PCN# 20260324001

General Updates from Revision -2 to -3 for

MitySBC-A5E  
All Variants

Date: March 24, 2026

Figure 1 -1/-2 "Old" Heatsink Mounting Hole Dimensions

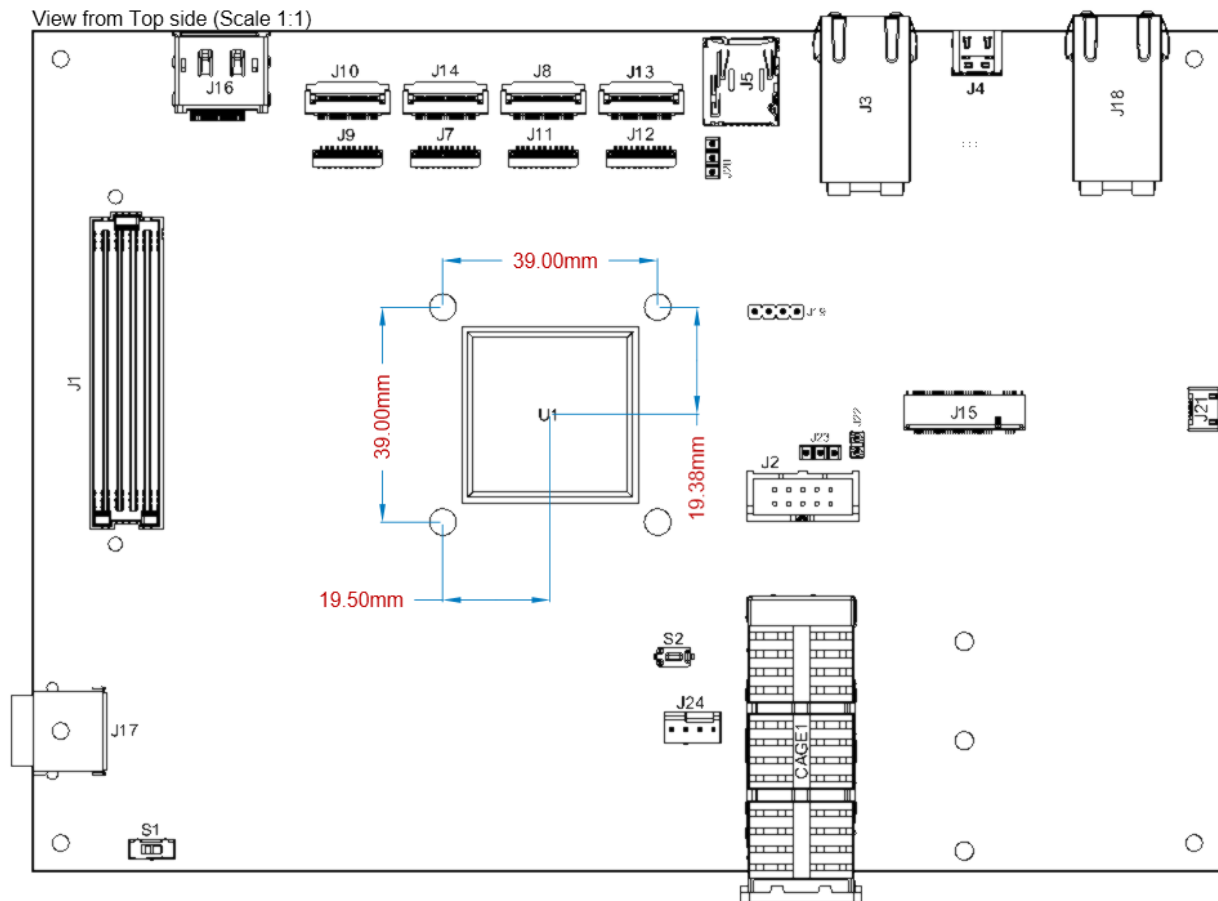
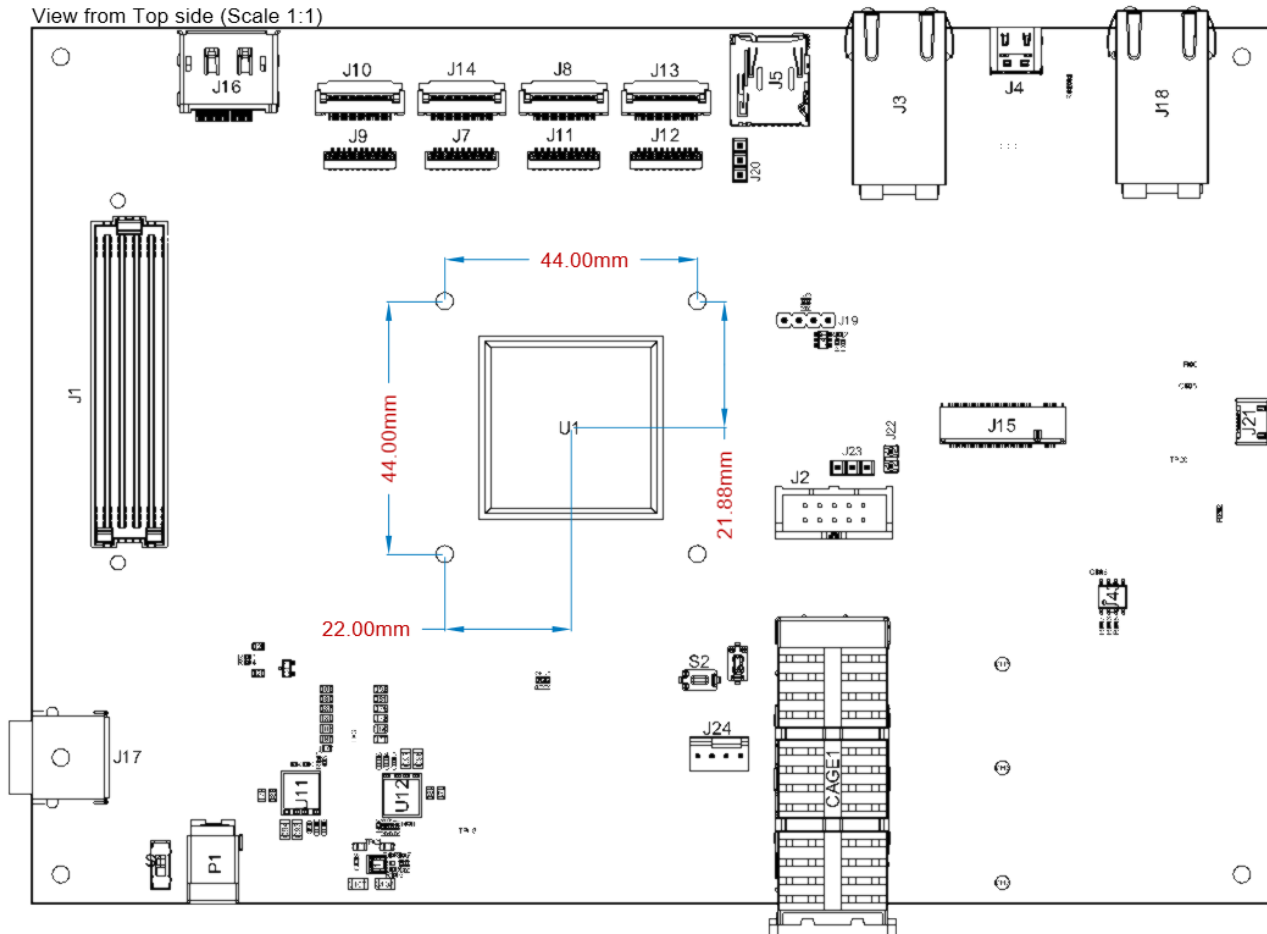
The through hole mounting holes intended for the Agilex 5 heatsink and fan were changed from Figure 1 to Figure 2.

The original mounting holes were designed for a customer heatsink, Heatscape HTSP-ASM-INT1-134-06-01, recommended by Altera. This heatsink and fan arrangement is not widely available, and prohibitively expensive.

The updated mounting holes allow for more widely available heatsinks, including the Advanced Thermal Solutions ATS-61500K-C2-R0.
